RE: 94 4th St. CPD;
DCI2024-00024

94 4TH ST.**Rezone****Request Narrative****Revised October 2024****2nd Revision March 2025****A. PURPOSE OF REQUEST**

**MASTER
CONCEPT
PLAN**

2. Connection Separation – [Section 10-285]

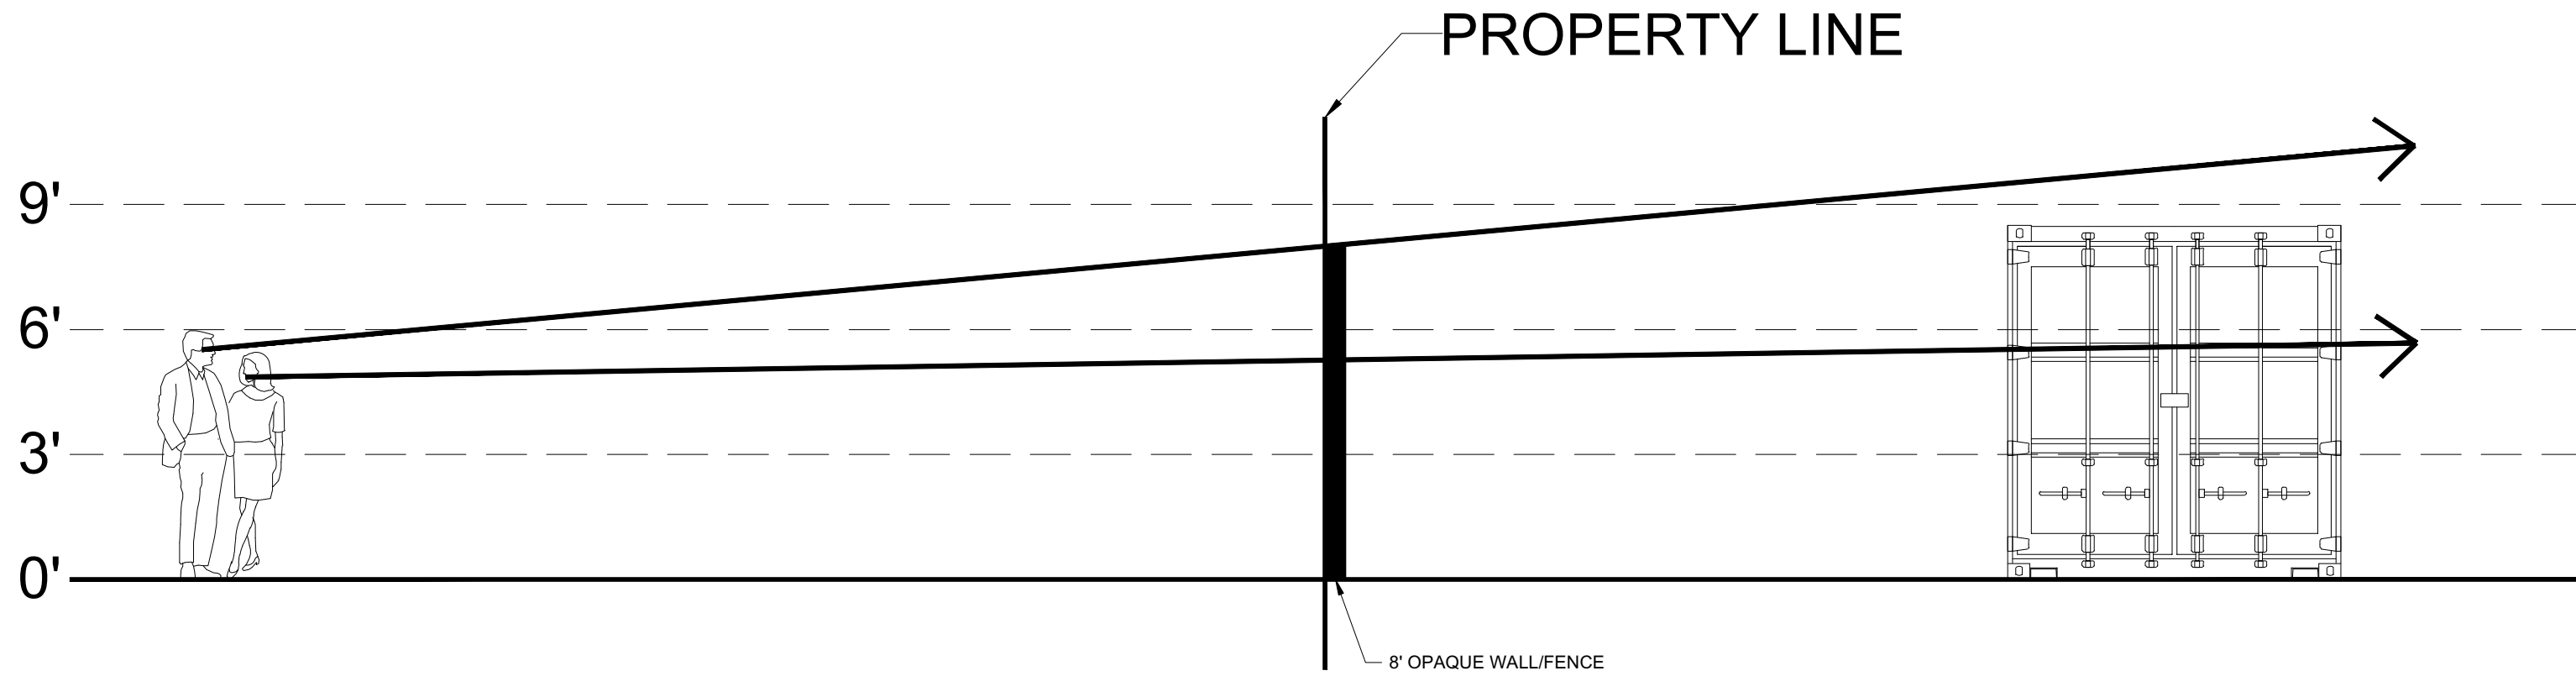
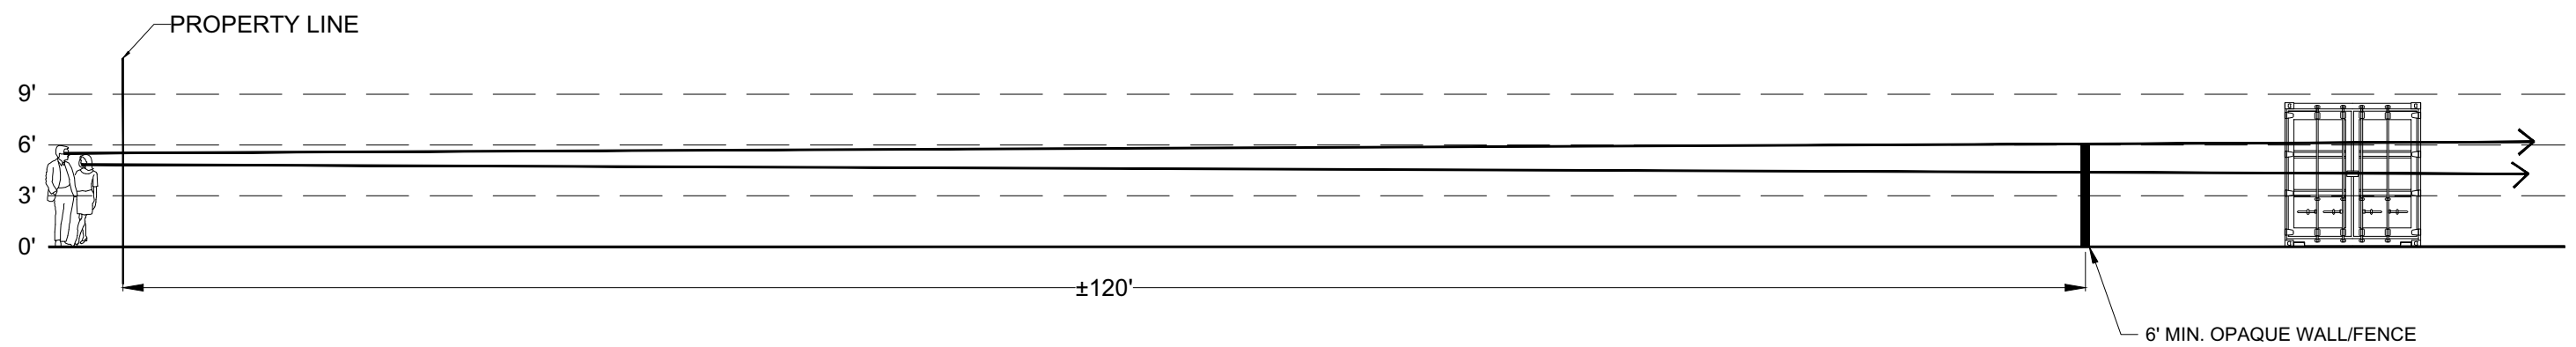
Request **from** the required connection separation of 60-feet **to allow** a separation of 38-feet between entrance points.

Justification: The existing driveway to the improved subject parcel currently requires a back out movement into the 4th St. right-of-way for the exiting movement from the existing driveway. The proposed deviation would allow replacing the existing driveway with two driveways at a separation of 38 feet, so that neither driveway would require a back out movement into the 4th St. right-of-way. This would be accomplished by providing internal turning movements to assure the two parking spaces provided at the north driveway and the one parking space provided at the south driveway may exit the subject property onto 4th St. in a forward motion. Existing improvements on the subject site, including, but not limited to, an existing septic system and a handicap ramp preclude connection between the two parking areas within the site itself. Also, providing a connection of the two driveways would cause elimination of a significant area of landscaping on the western side of the property, which would negatively impact the minimum buffering requirement.

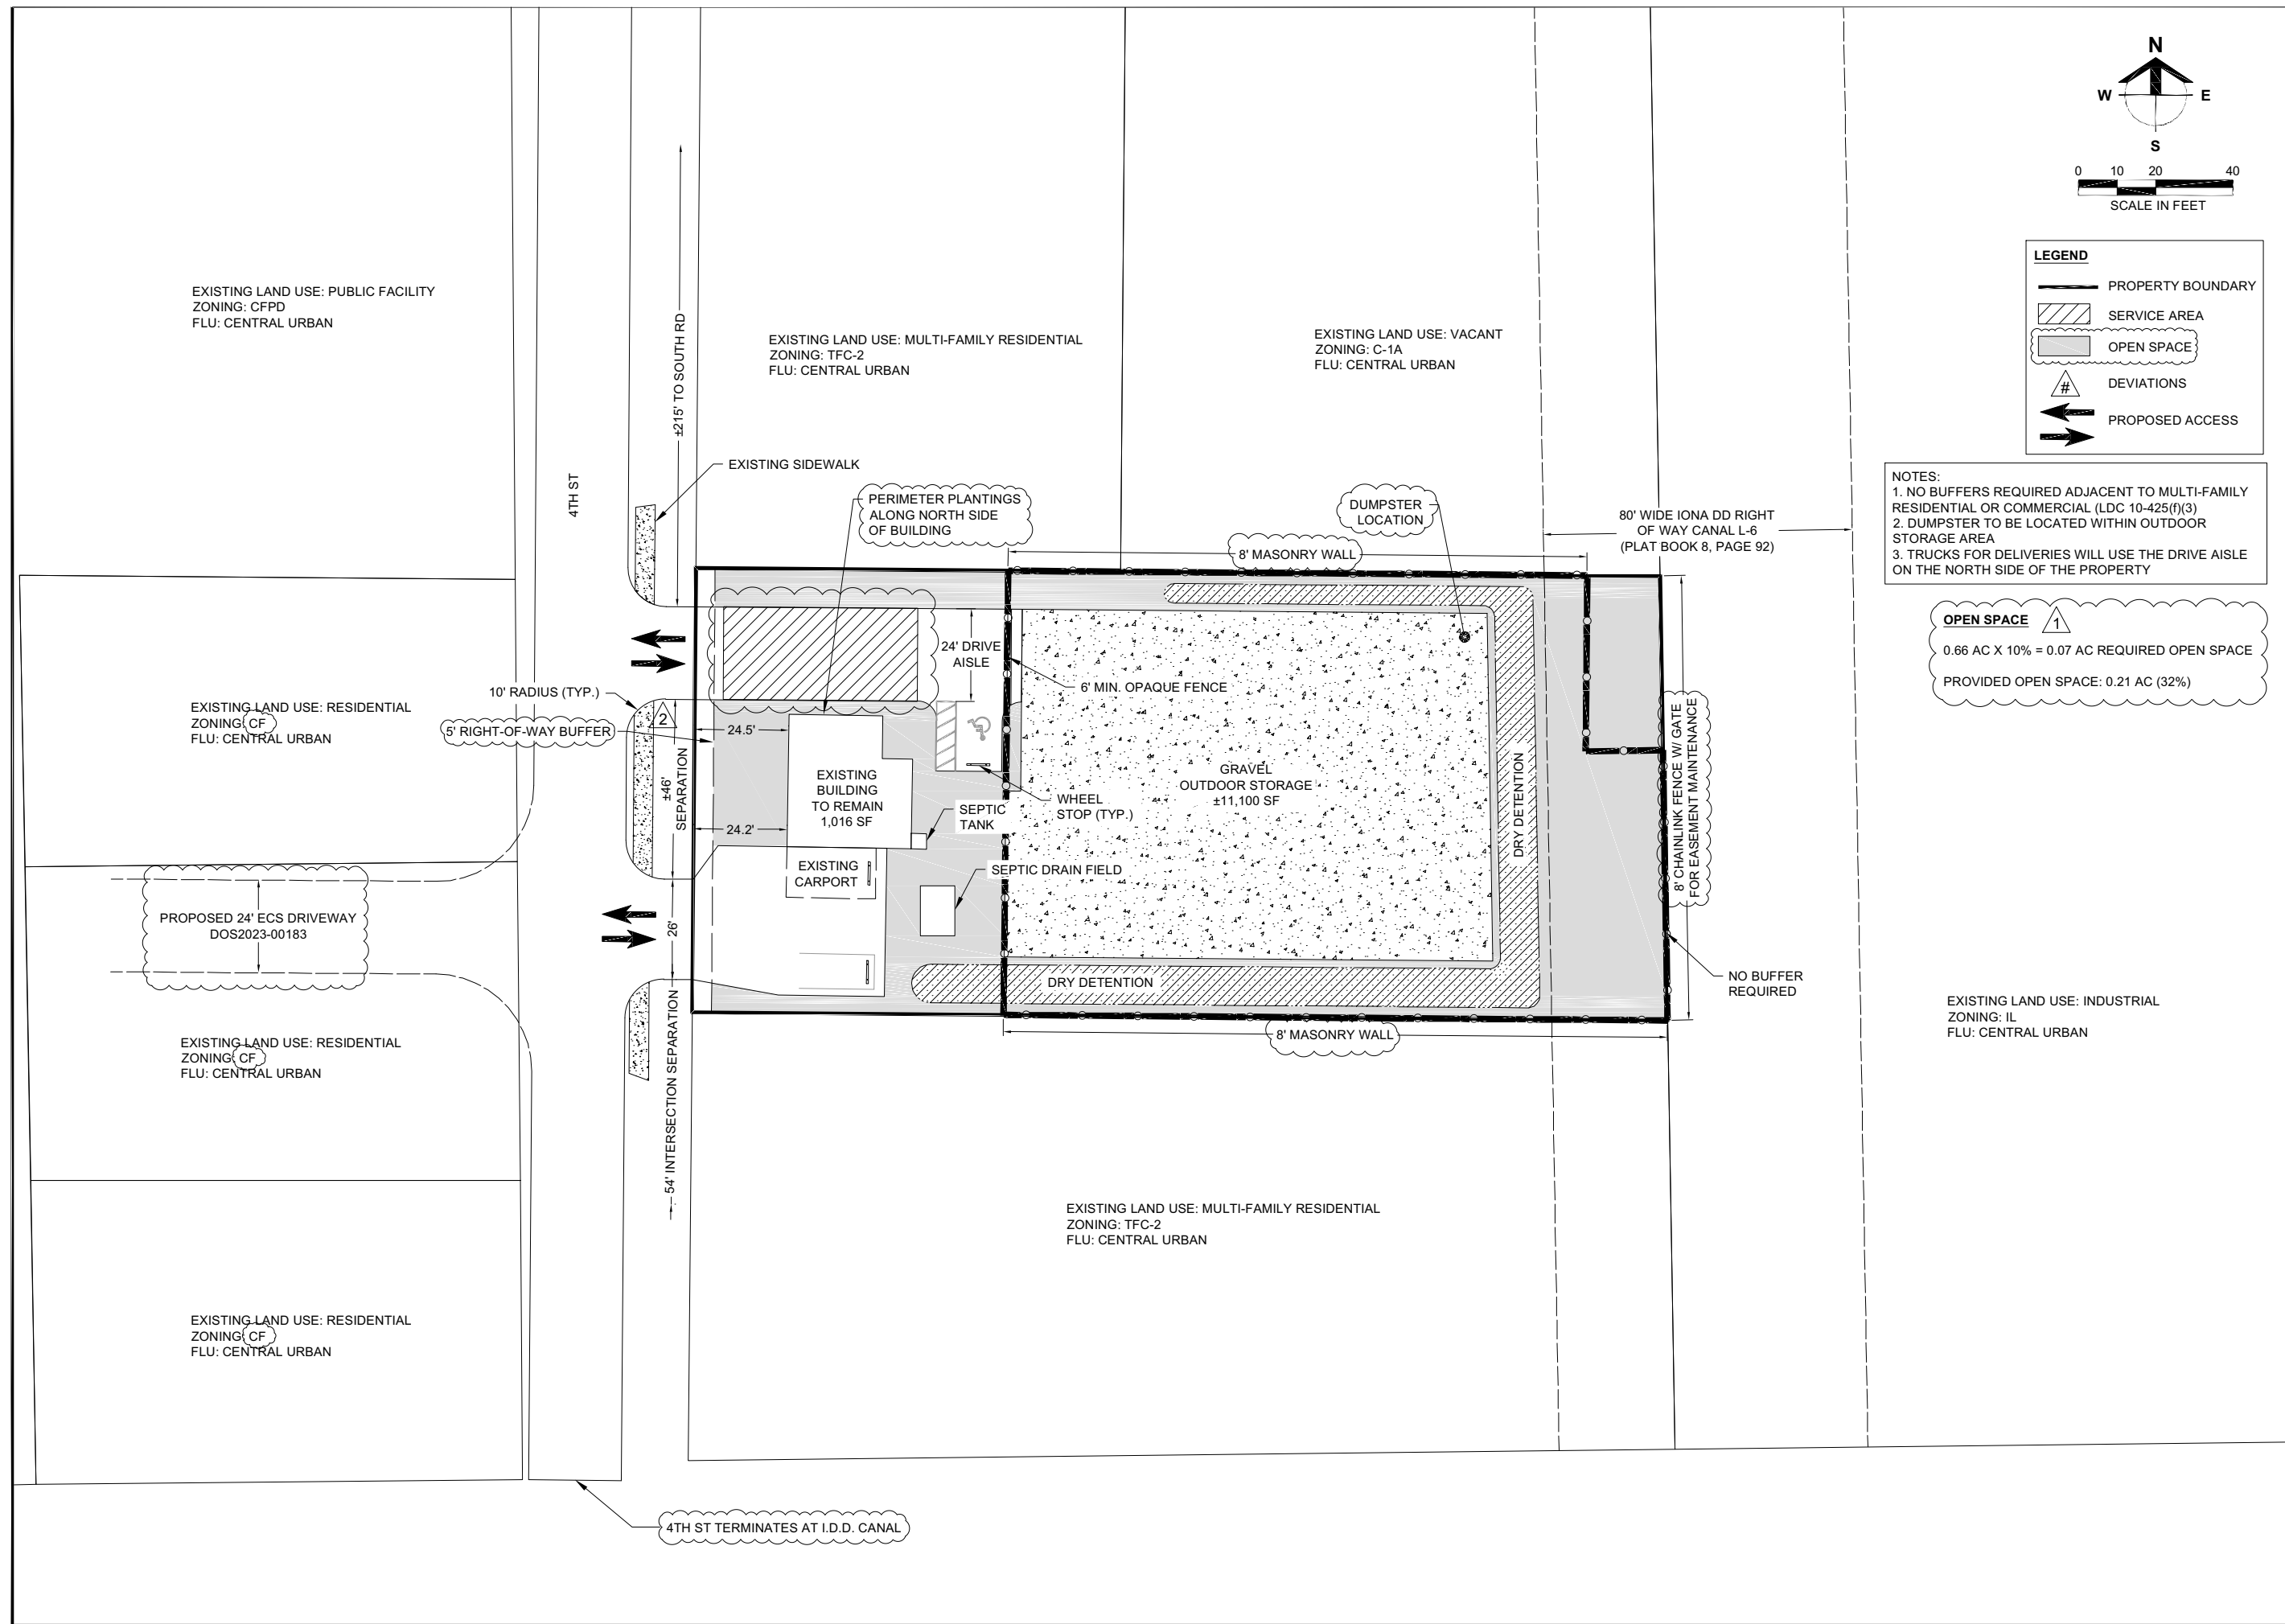
Please clarify the purpose of the triangles on the MCP with the letter "R". It is unclear if these markers correspond to proposed deviations or indicators that the areas are to be included in the open space calculation. If it is the latter, please remove the additional triangles as the bubble annotation communicates the correlation well enough

Please revise the MCP to show clear distinction between property lines and the masonry wall as well as chain link fence as proposed with alternate hatch marking.

The MCP calls out an 8-foot masonry wall and an 8-foot chain link fence, but these are represented by the same feature (black line) on the MCP. The same feature is on the west parcel line, yet no wall is referenced on the MCP on that boundary. Clarify the location of walls on the MCP.

The triangles were used to denote revisions that were made based upon comments received. They have been removed for clarity.

The distinction between lines has been amplified for easy identification. The property line is distinguished by the thin black line and the masonry wall is distinguished by a thicker black line. It is also called out on the Plan.

The interior fence is marked in thick black and contains small circles for easy identification.

The masonry wall (on the perimeter) has been highlighted in a different line type and the opaque fence (interior) has been highlighted accordingly with a distinctive demarcation.
